Agenda
Village of Arlington Heights
Design Commission
Community Room, 3rd Floor
Arlington Heights Village Hall, 33 S. Arlington Heights Rd.
January 10, 2023
6:30 PM

Item: DC#22-073 - 1245 S. Arlington Heights Rd. - SF/Teardown

Item: DC#22-059 - 1518 N. Vail Ave. - SF/Teardown

Item: DC#22-080 - 1319 E. Clarendon St. - SF/New

2 PROPOSED ARLINGTON HEIGHTS ROAD CONTEXT ELEVATION
1/16" = 1'-0"

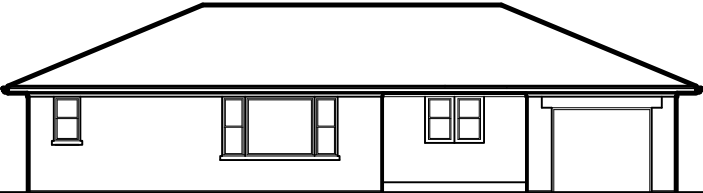
Overall, the proposed design is nicely done with a farmhouse aesthetic with white siding, board and batten siding accents, white windows and a gray roof. However, all of the surrounding properties to the north, east, and south have full brick masonry exteriors. The house will be highly visible from Arlington Heights Road, and the proposed farmhouse style feels somewhat random with the context in this location, which the Design Commission should evaluate.

1. Evaluate the proposed farmhouse style design with the character of the surrounding context in this location.
2. This review deals with architectural design only and should not be construed to be an approval of, or to have any other impact on, any other zoning and/or land use issues or decisions that stem from zoning, building, signage or any other reviews. In

FRONT ELEVATION
REAR ELEVATION

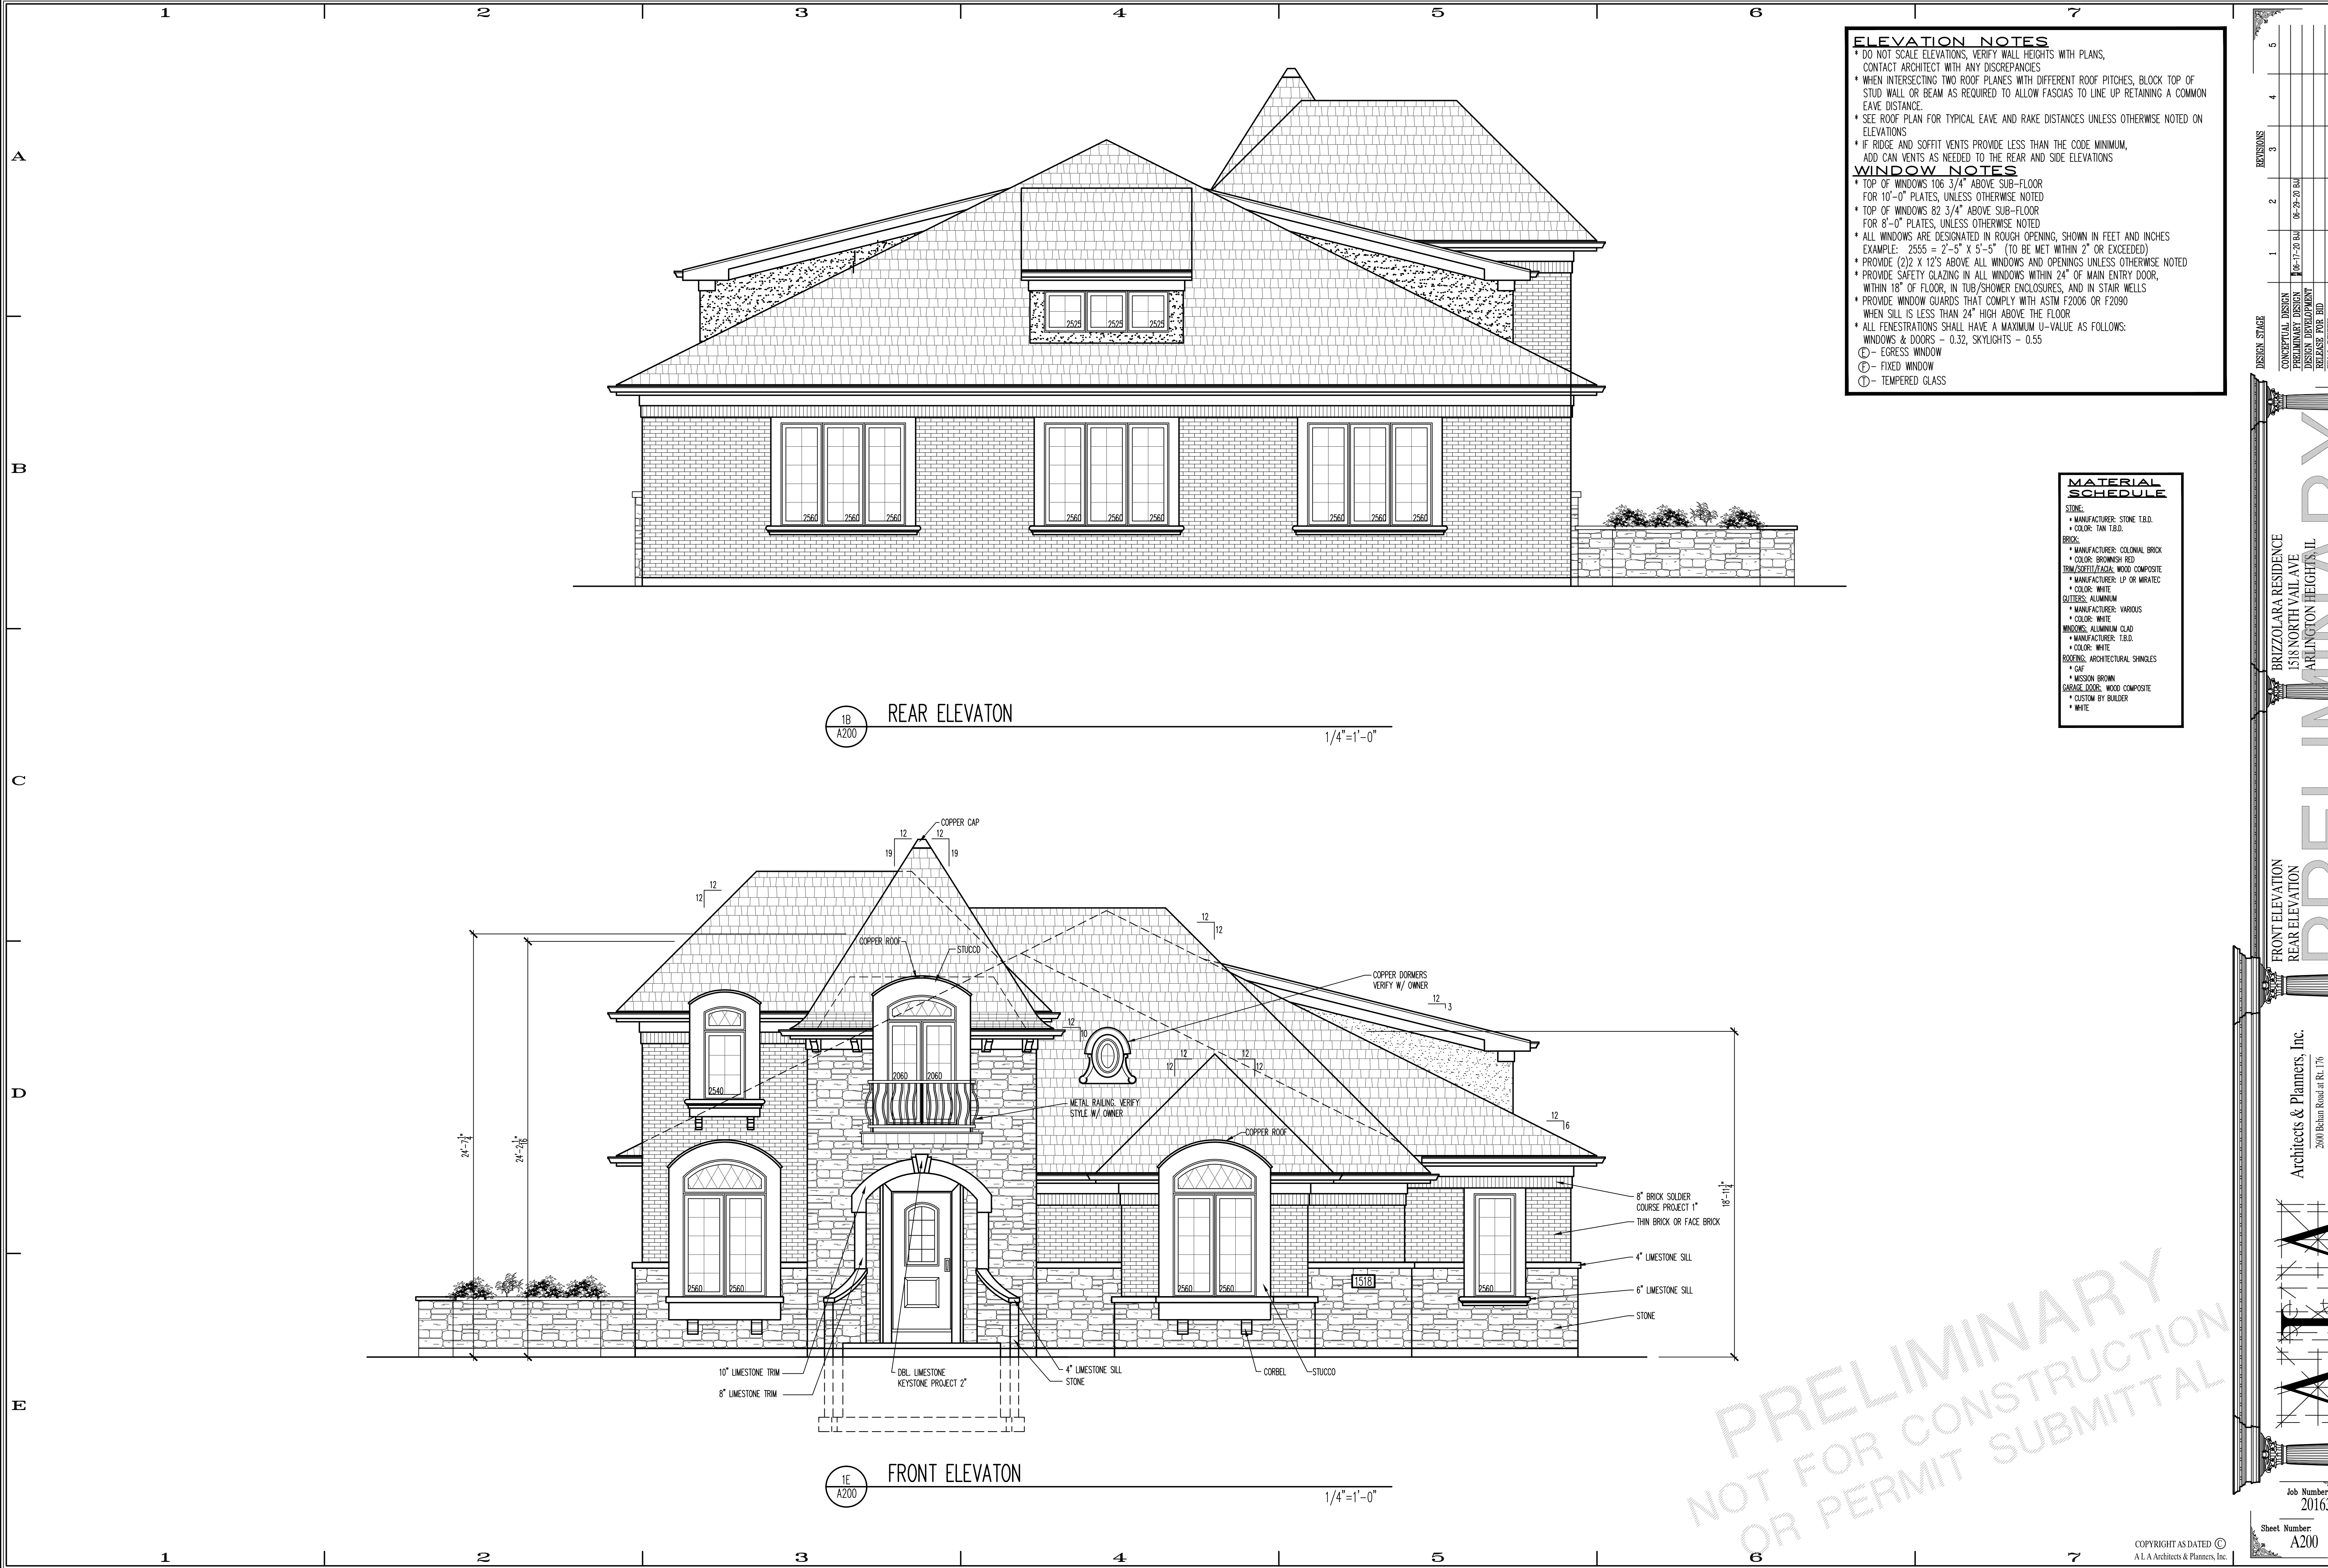
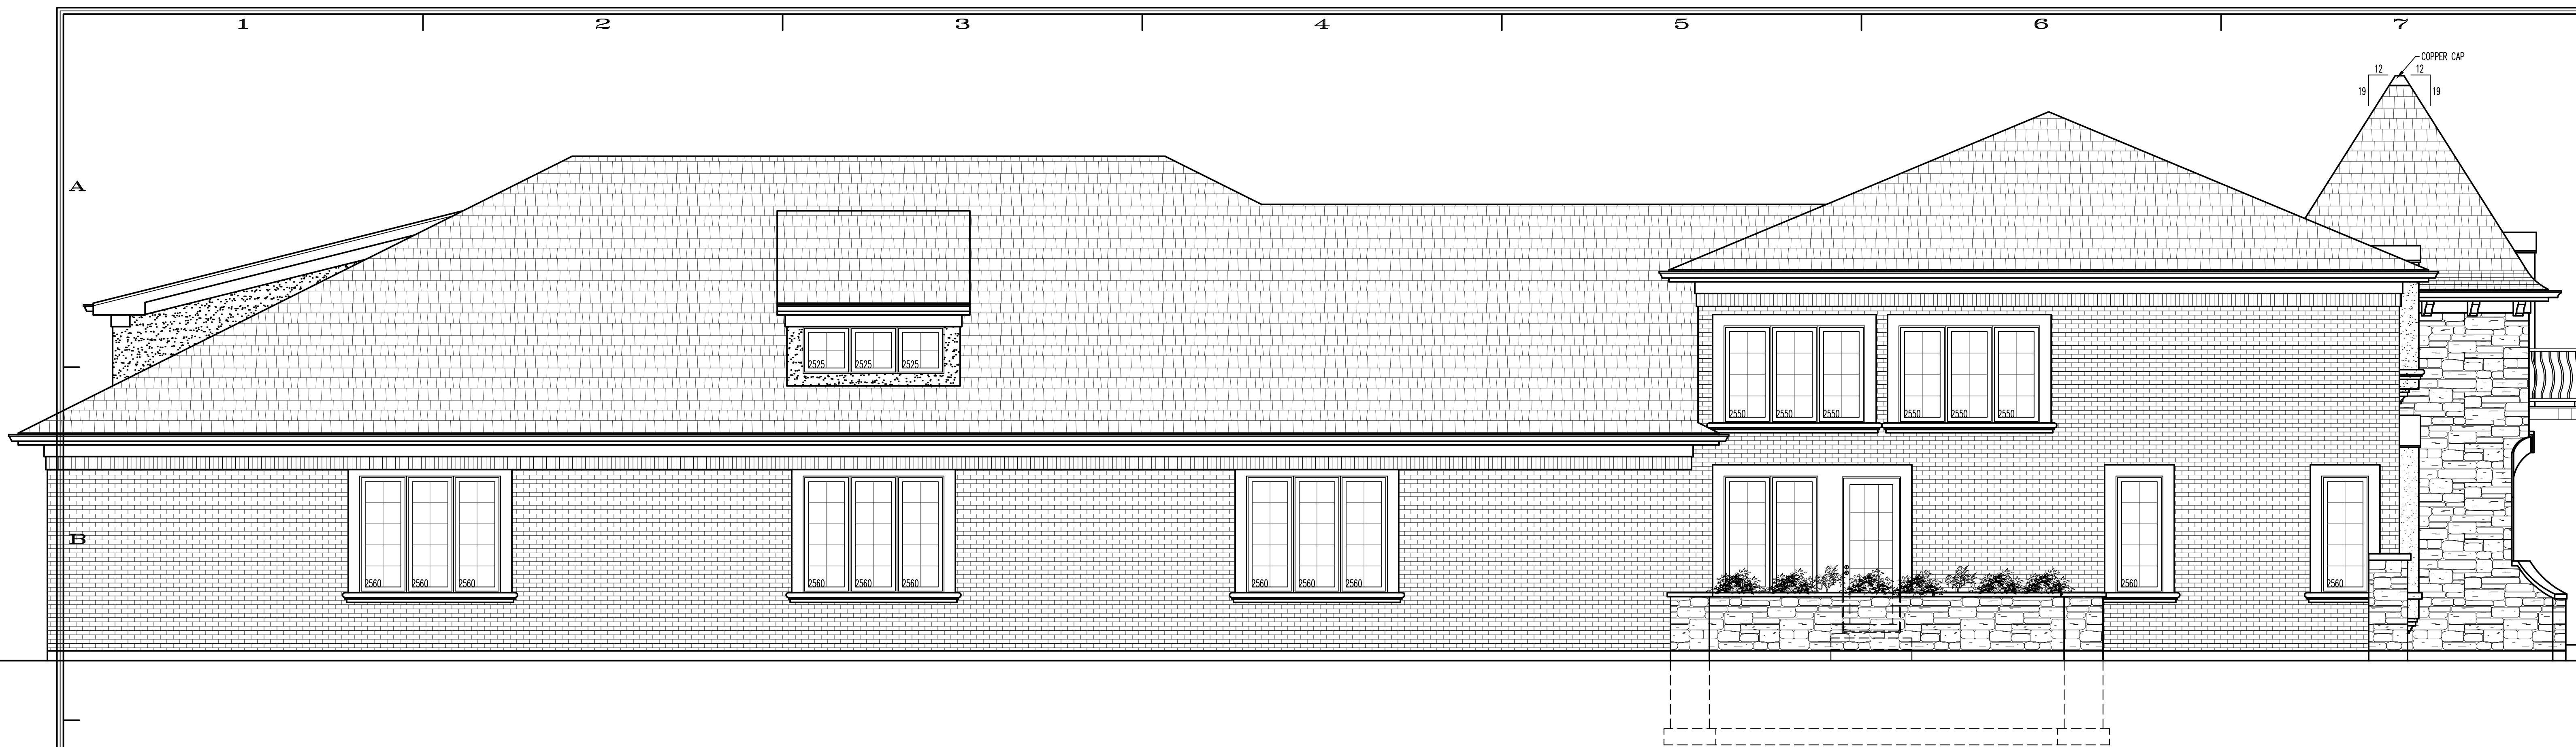
character of the neighborhood. However, the large boxy rear of the home feels mismatched with the front of the house. For a more cohesive overall design, it is recommended that the design and massing of the rear Great Room be further developed with varied roof lines, dormers, and detailing to better fit with the front of the house.

As I look at the exterior, I love the front of the house. I think it fits great in the neighborhood. I agree with you that the rear of the house is very plain and boxy. It's completely different that the front of the house. I definitely agree that they need to vary the roof lines, add dormers and more detail to match the front of the house.

When I look at it, my initial thought is that they're trying to disguise a smaller basketball court inside a house. Not only the view from the rear but the left elevation as well. It is completely flat on that side and has no contour. No variation in window sizes and very uniform. Also, is this house going to have a fireplace? Maybe I'm missing it but I can't imagine a \$2m build without a fireplace. And in the rear of the house, I don't see an exit leading to the back yard. I don't see any kind of door whether it's a sliding door, French door or other.

1. Evaluate the large and boxy rear of the home which is mismatched with the nicely designed front.
2. For a more cohesive overall design, it is recommended that the design and massing of the rear Great Room be further developed with varied roof lines, dormers, and detailing to better fit with the front of the house.
